Handover REPORT (hereinafter called the "Report")

Inspection Date: 10/11/2015

Property Address: 41 sample Circuit Sample QLD 4164

Figure 3.1.2.2

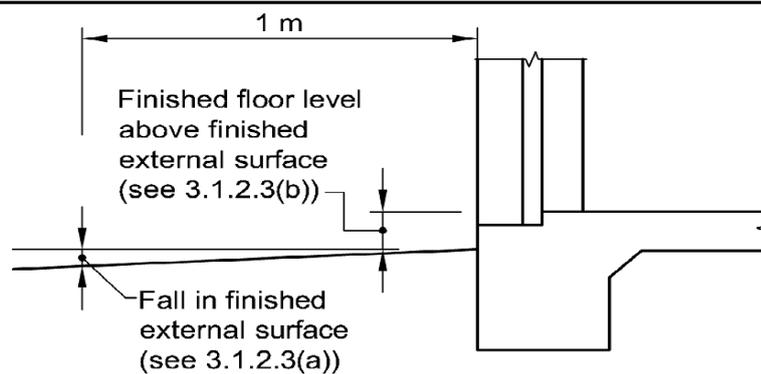
What it is: Ground levels inadequate.

Results: Ground levels are inadequate and can cause water to lay against the footings.

I refer the Builder to Slab-on-ground-finished slab heights: the height of the slab-on-ground above external finished surfaces must be not less than (see Figure 3.1.2.2)-

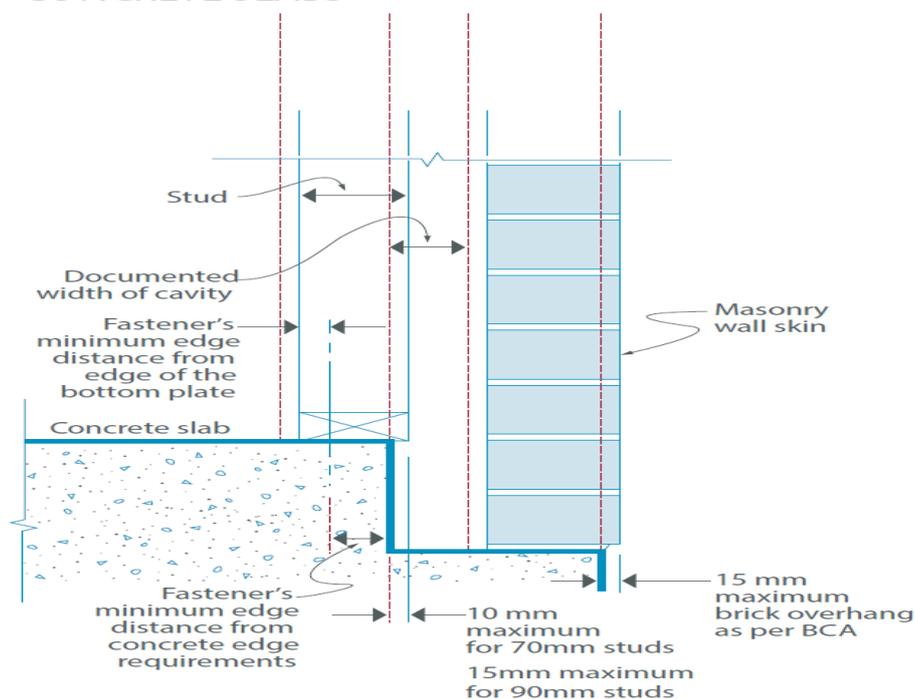
What it is: Brick over-hang.

Results: The brick over hang to the dwelling needs to be supported. The BCA, part 3.2.2.7 calls for a maximum overhang of 15 mm. All must be reworked and supported in accordance with AS 2870 prior to handover.

Where it is: Front Windows

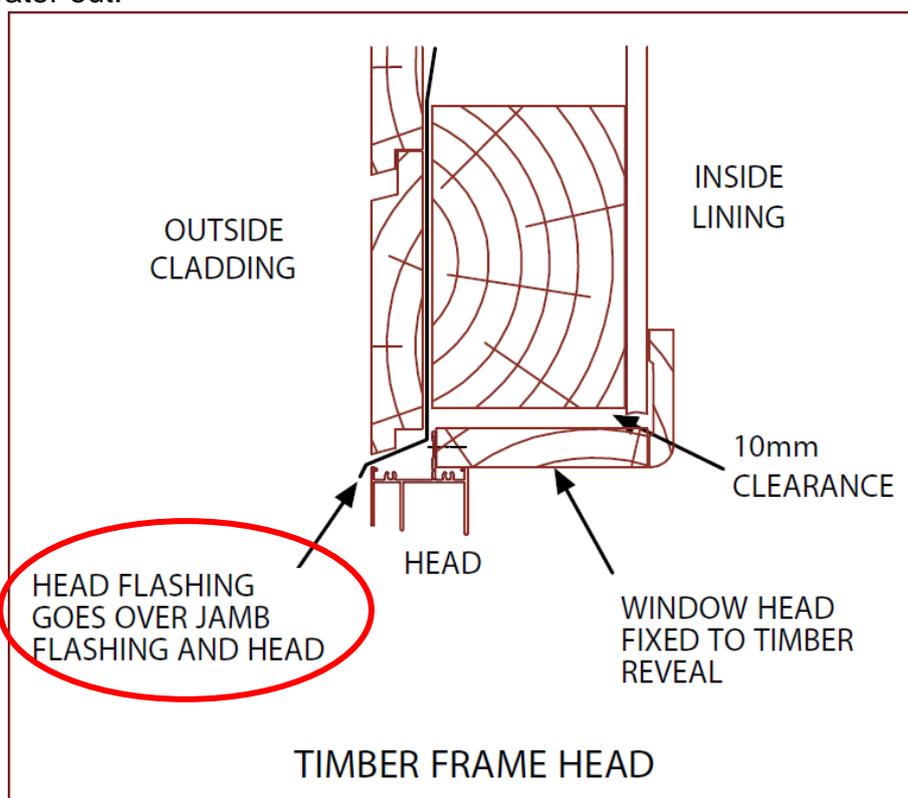
What it is: It appears the window have no header flashing installed

Results It was noted that windows don't have header flashing installed for weatherproofing. All needs to be reworked before handover and Deemed-to-Satisfy Provisions are an optional means of achieving compliance with the mandatory Performance Requirements of BCA/NCC. The Australian Window Association (AWA)

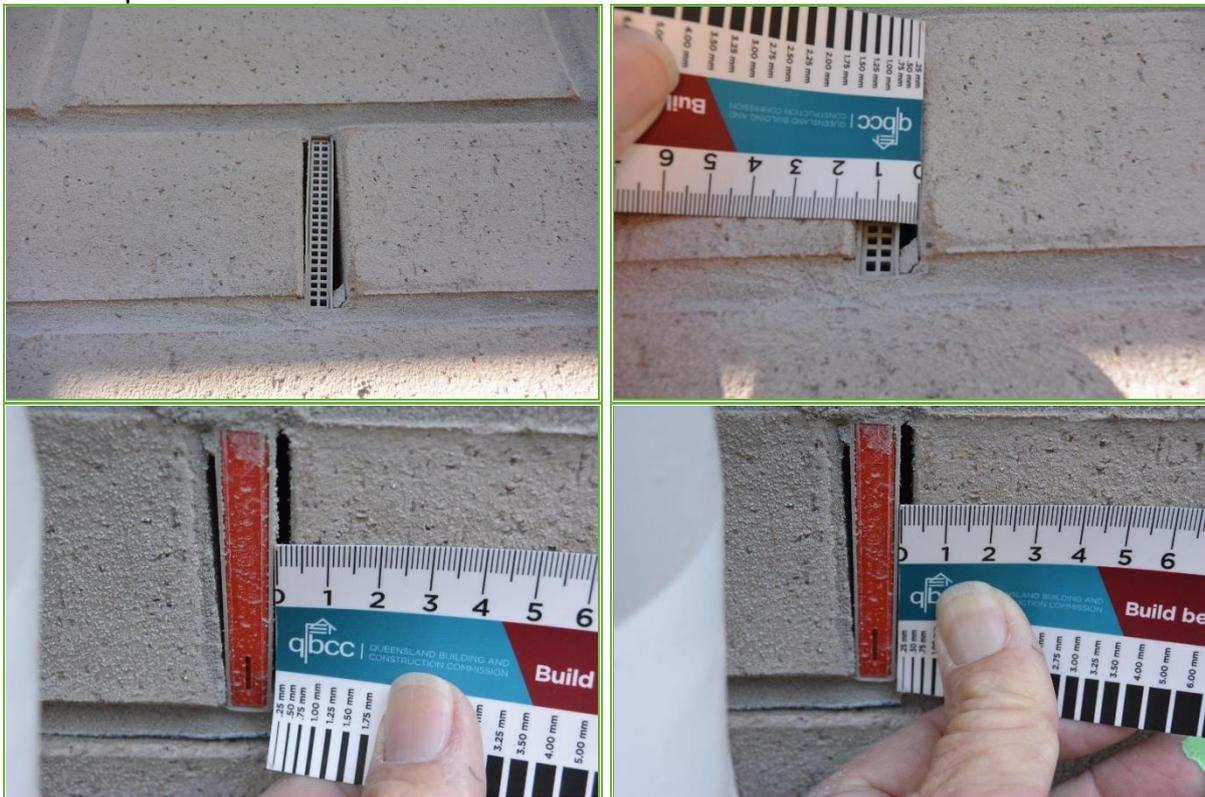
What it is: The dwelling has a Fire Attack Rating of 12.5. Must comply with AS3959

Results: At the time of inspection there was number of defects that do not comply with the rating of 12.5 Fire attack. The BAL was introduced to stop ember attack to dwellings rated at 12.5 needs to be rectified before handover. As per AS3959

1. Weep holes not to BAL 12.5

Where it is: Internal Dining Room Wall

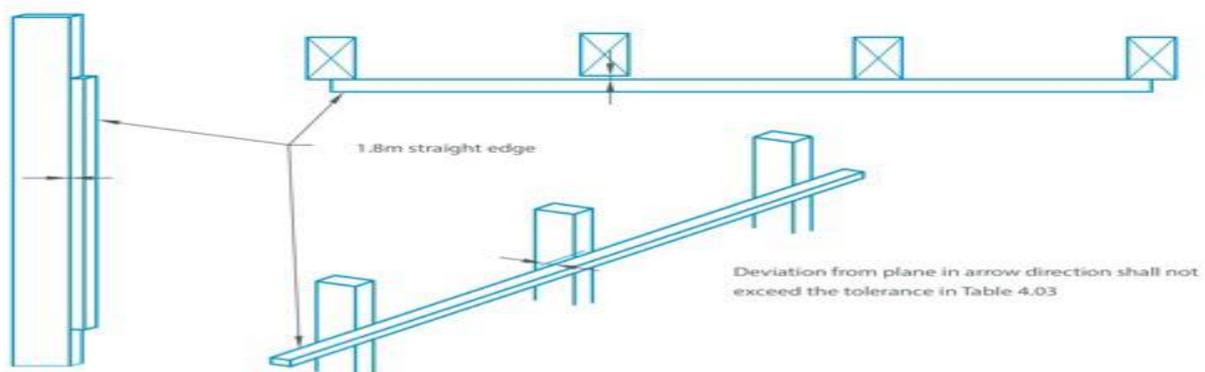
What it is: Wall exceed the allowable allowance of 4mm

Results: Wall exceed the allowance of 4mm framing finish needs reworking to minimum Standards.

Where it is: Bathrooms

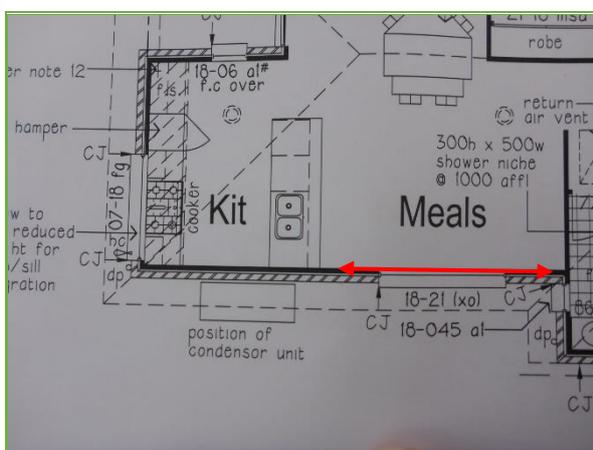
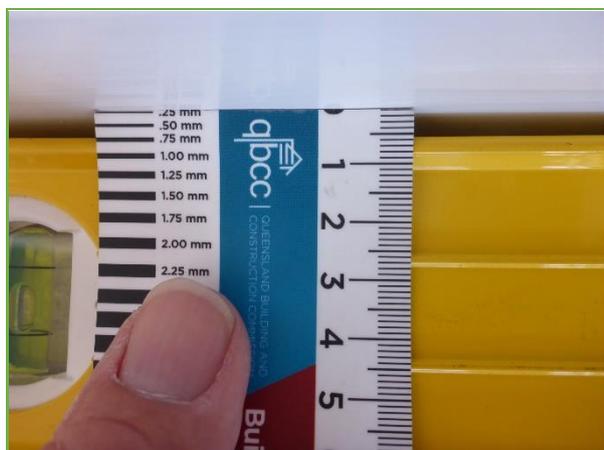
What it is: Shower nook not draining away and the waste is too high water will not drain away, and lippage more than the allowable rate.

Results: It was noted at the time of inspection after testing the shower, the nook and base appears to be holding water and there are tiles that are level and have some back fall to the wall and waste is too high, this is preventing the water from draining to the floor waste, this will need to be reworked to the minimum standard set out as per, I refer the Builder to, 103 AS 3958.1-2007 Appendix D FALLS IN FLOOR FINISHES D1 General.

Where it is: Roof and Guttering

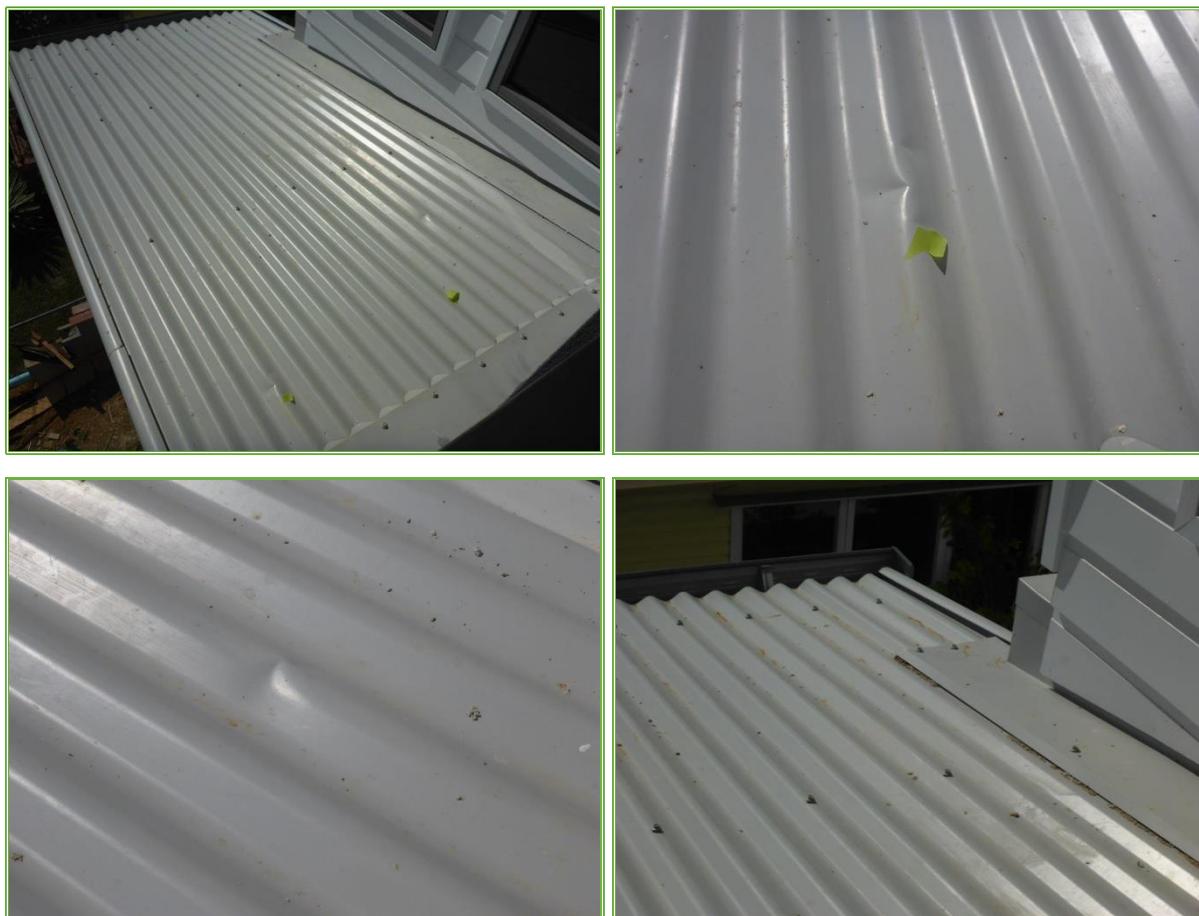
What it is: Dents and marks

Results: Roofs are defective if they are dented or mark in the first 12 months of completion, this will need to be replaced under the Builders Warranty. I refer the Builder to Below to QBCC Standards and Tolerances.

Where it is: Back Garage Block Wall

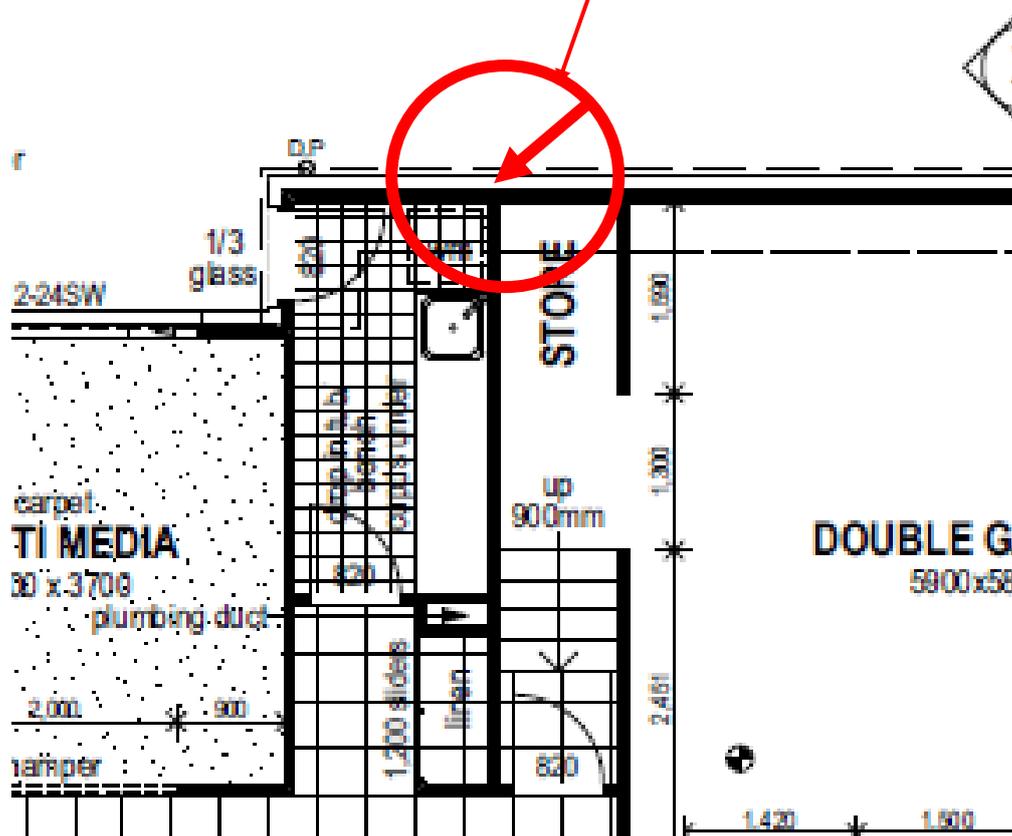
What it is: Blockwork not as per plan

Results: It was noted at the time of inspection that garage wall block work is too long not as per plan and elevation (2) almost a full block sticking out passed the finish external wall and encroaching on the boundary and becoming an obstacle. This will need to be rework to comply with the plans.

Where it is: Front Elevation

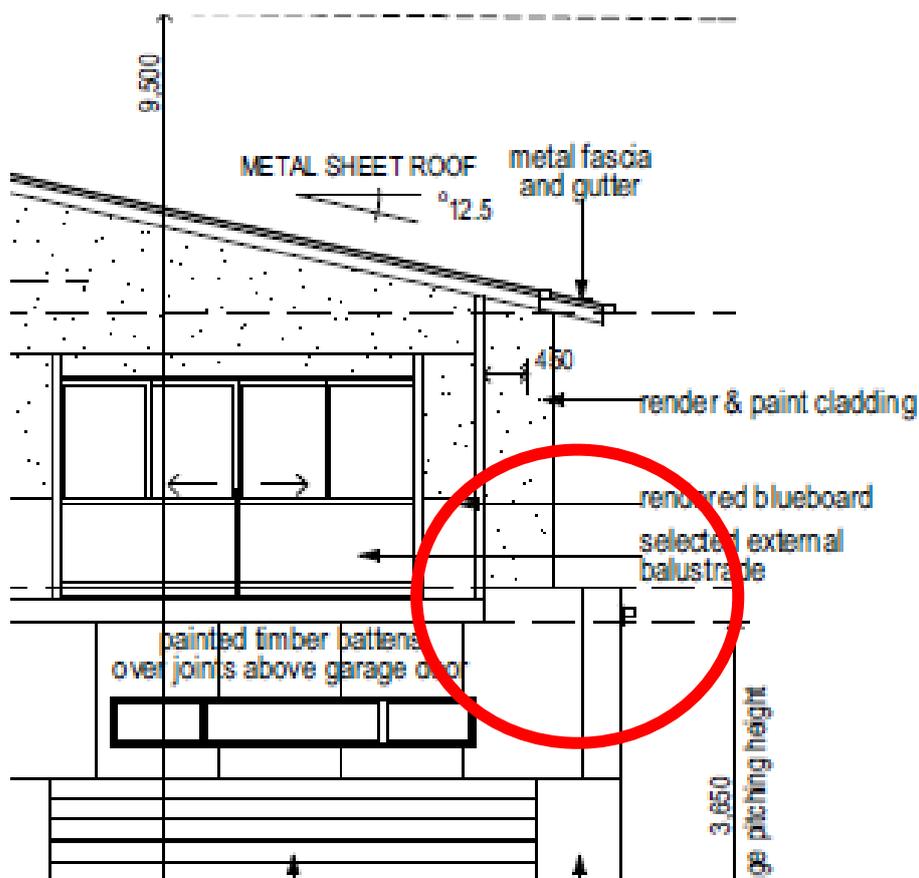
What it is: Building not as per plan

Results: It was noted at the time of inspection that front elevation (1) the roof fascia is incorrect, there is no parapet, not as per plans. This will need to be rework to comply with the plans.

Where it is: External Areas

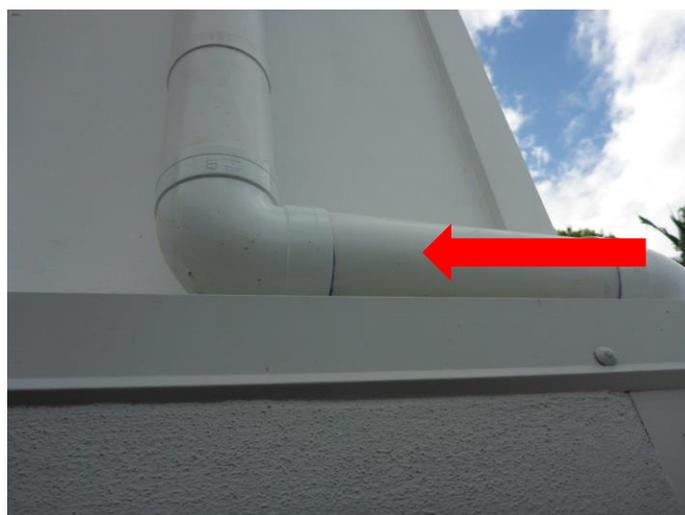
What it is: Pipes not painted and still need to be finished.

Results: Some of the stormwater pipes have not been painted, this needs to be rectified before handover. I refer the Builder to the insert:

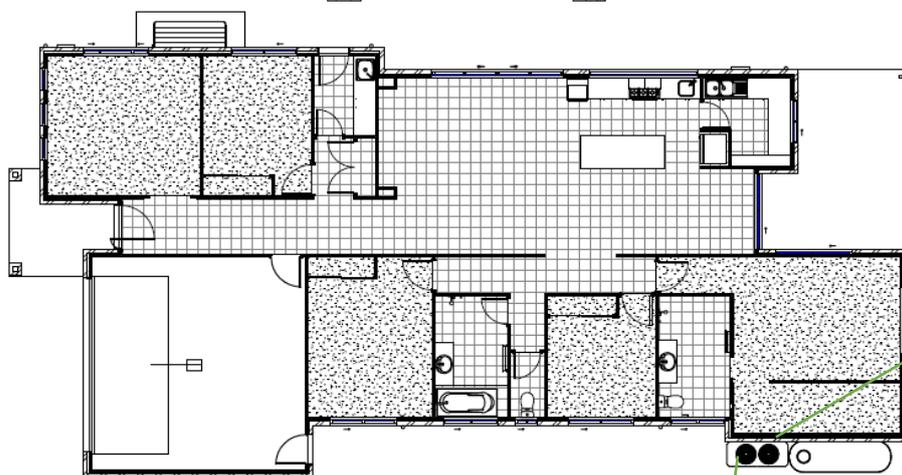
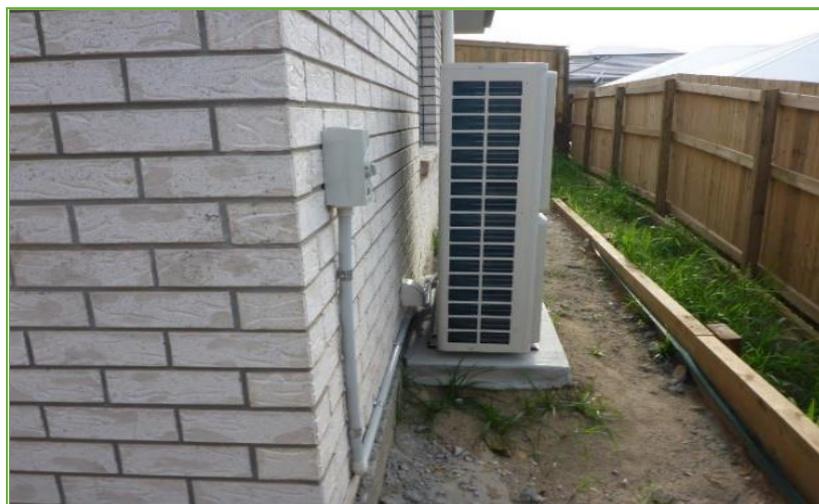
What it is: Air-conditioning not in the correct area as per plan.

Results: It appears that the system has been installed incorrect location and hinders access and is a potentially safety hazard. It should be installed so it does not interfere with the normal operation of any access with any other aspects of the normal operation of a building: Where it does not cause a nuisance or injury to person. This is clearly a nuisance and is potentially a safety hazard and it clearly interferes with the normal access pathway.

This will need to be re-location before handover.

Where it is: External Plumbing to

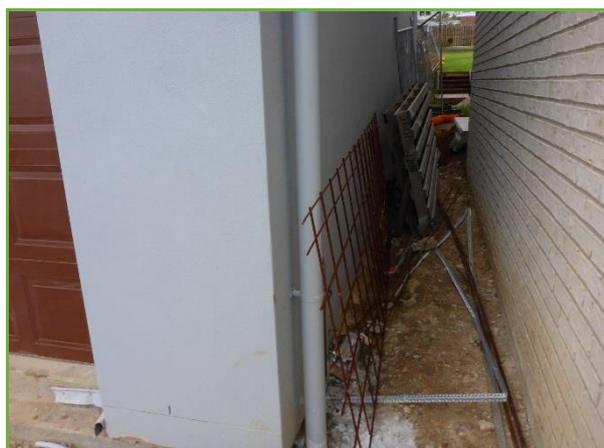
What it is: Damage IO pipe and Water Meter Box.

Results: At the time of the inspection the pipe and the water meter box was damaged, this will need to be re-place before handover. I refer the builder to Standards & Tolerances 2016

Where it is: Internal Doors

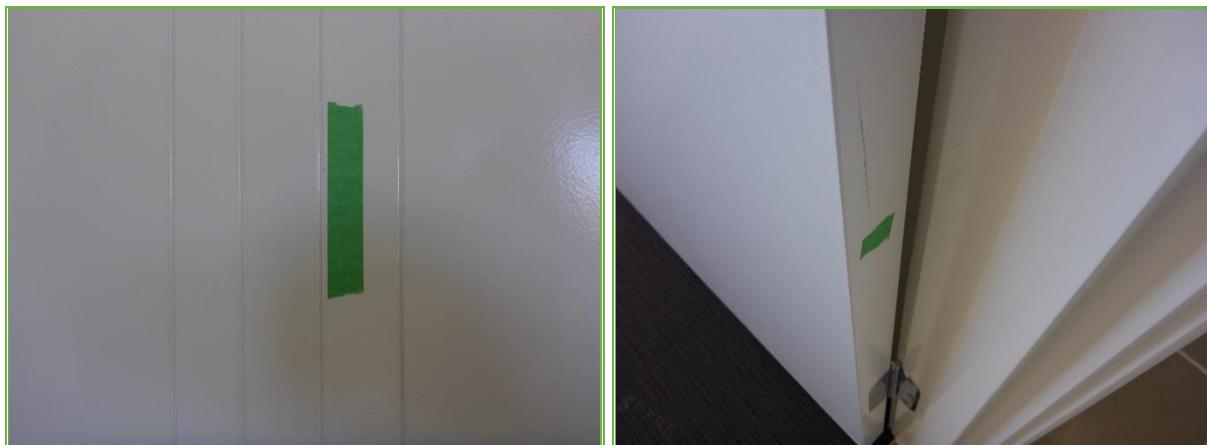
What it is: Door Staved Painting

Results: It was noted at the time of inspection the most of the internal doors appeared to be staved of paint coverage, all will need to be reworked before Hanover.

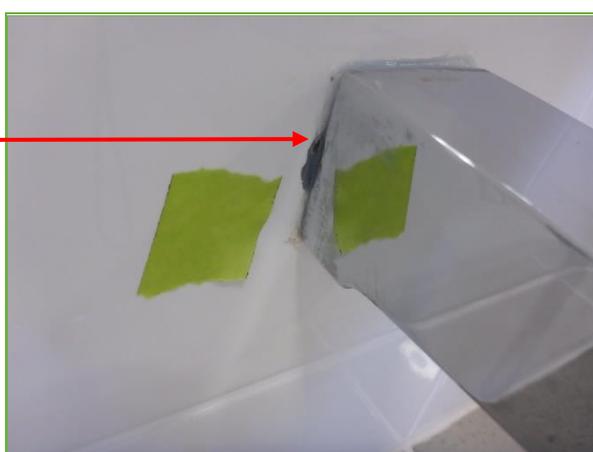
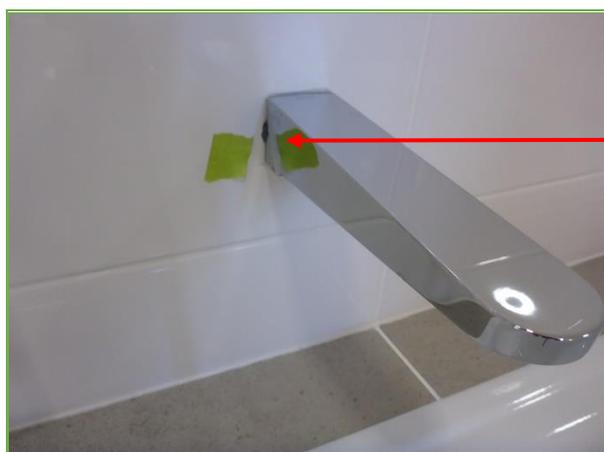
1 Bedroom 2 door not locking

2 Ensuite shower flick-mixer damaged

3 Main bathroom scratched tile.

4. Bathroom Chipped Bath and overcut tile around the spout.

Where it is: Numerous areas

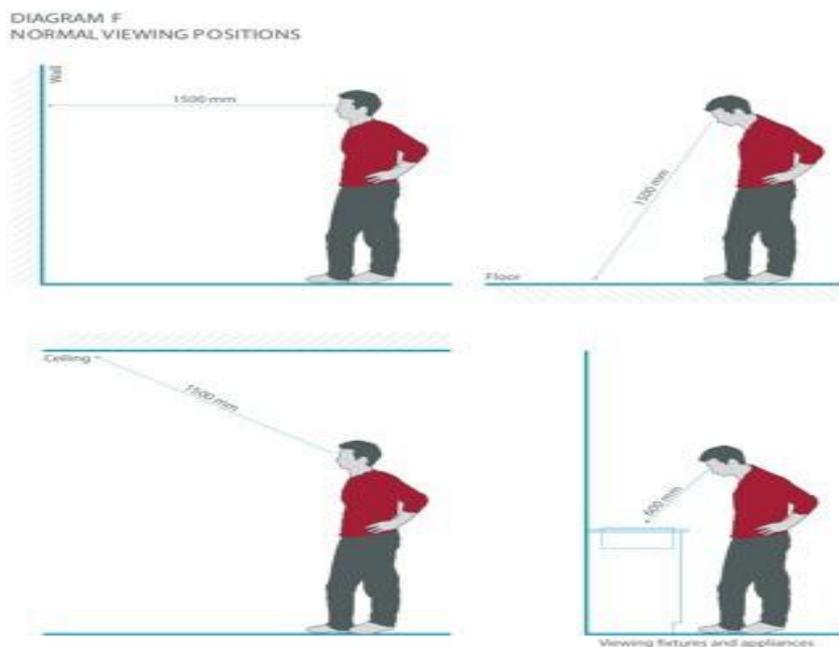
What it is: Incomplete works. (cleaning, paint, areas not sealed, kitchen, Drive way, numerous areas)

Results: At the time of inspection it was noted that the building is not ready for practical completion or handover as there is numerous incompletd works. These incomplete works will need to be finished before this is deemed ready for pracitical completiion or handover as per contract. The Domestic Building Contracts Act May 2015. It is clearly not suitable for habitation.
